**SECTION 00 90 01
BIDDING AND CONTRACT REQUIREMENTS
ADDENDUM NUMBER (04)**

Issued: May 6, 2024

Bid 24-032 Elgin Sports Complex Expansion

Architect's Project Number: 14106

SHEET NUMBER A-111

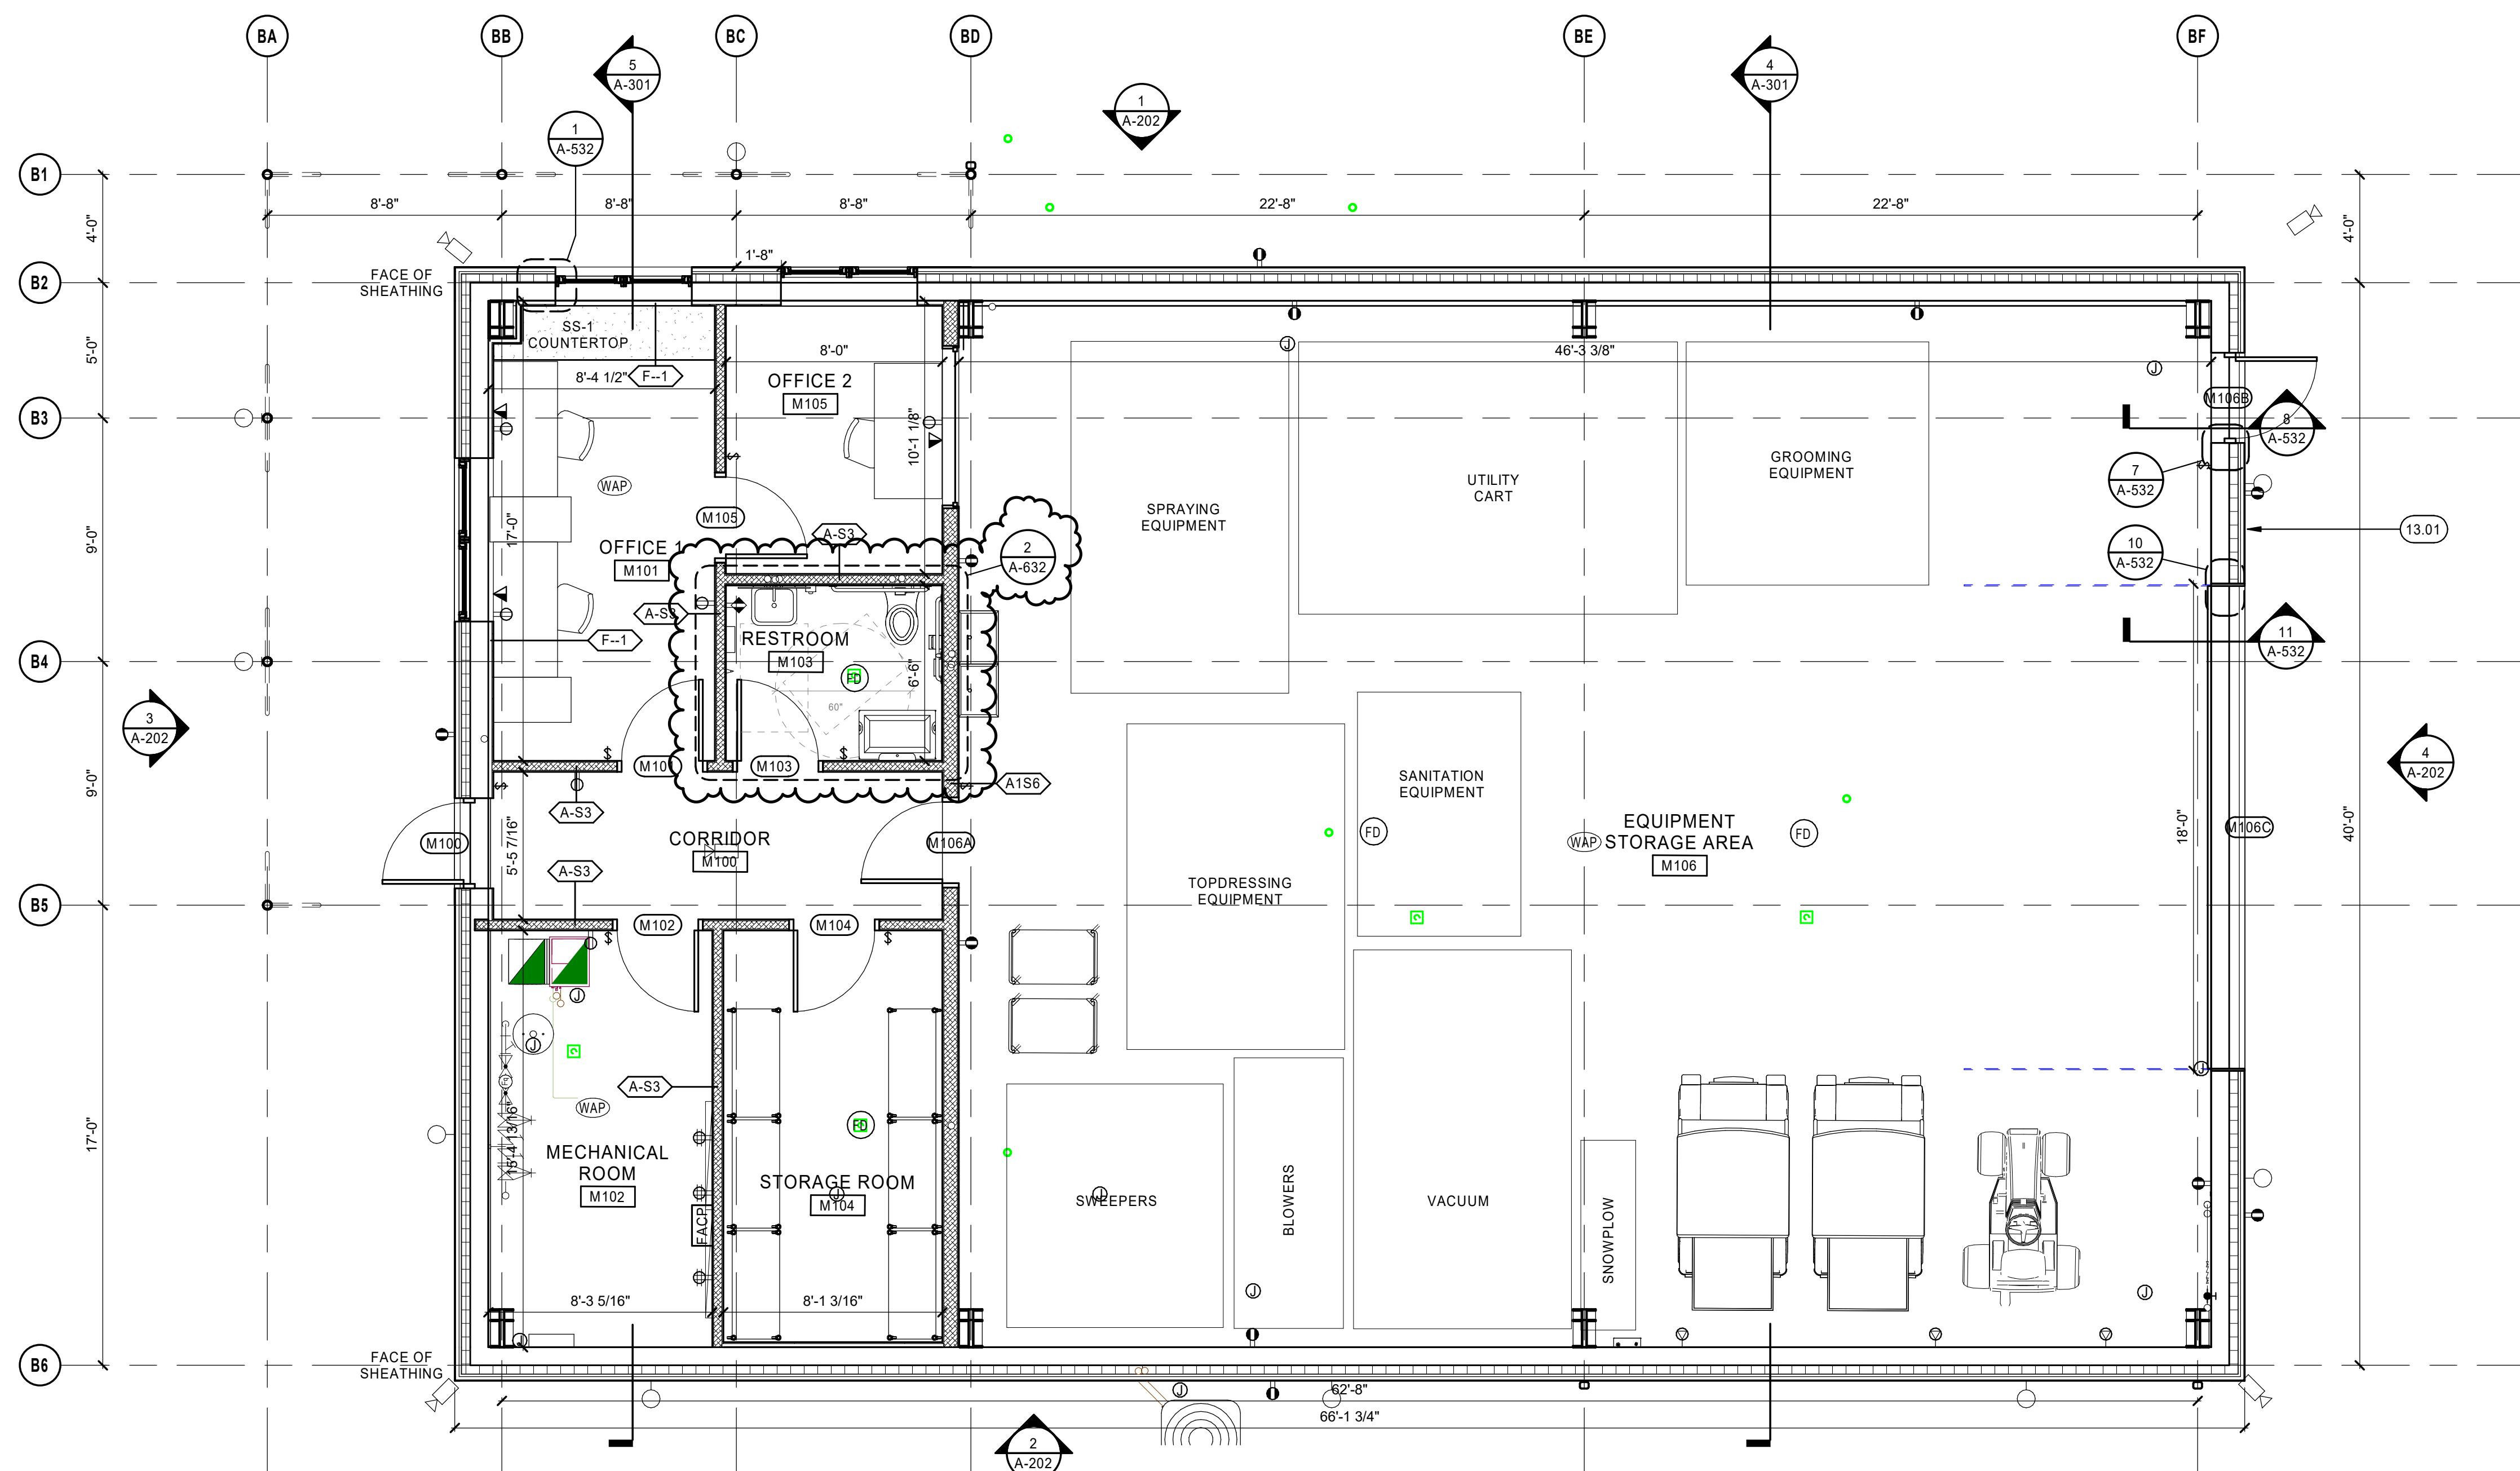
14. Spec. 1.1 B. 1. References 077253 "snow guards", but no such section exists and there are no snow guards shown on the roof plan or sections. Please advise if this can be removed. **Please provide snow guards at all guttered/draining edge of roofs at Concessions and Maintenance**

Buildings; drawings will be updated to indicate exact locations, and missing specification information will be provided, see Addendum 4 Volume 2 drawings and specifications.

- 07.51 PROVIDE SNOW GUARDS (AS SPECIFIED, DIV 07) CONTINUOUS AT EDGE OF ROOF AS INDICATED.
- 08.03 36" x 36" COMMERCIAL-GRADE THERMOPLASTIC RUBBER LOCKABLE ALUMINUM ROOF ACCESS HATCH (NYSTROM, THERMALMAX OR EQ.)
- 13.01 MAINTENANCE BUILDING ABOVE-GROUND STRUCTURE AND EXTERIOR ENCLOSURE, BY PREFABRICATOR, U.N.O.
- 48.01 AREA RESERVED FOR ROOF-MOUNTED PV ARRAY (BY OTHERS, NIC), NO OTHER ROOF MOUNTED EQUIPMENT OR PENETRATIONS IN THIS AREA
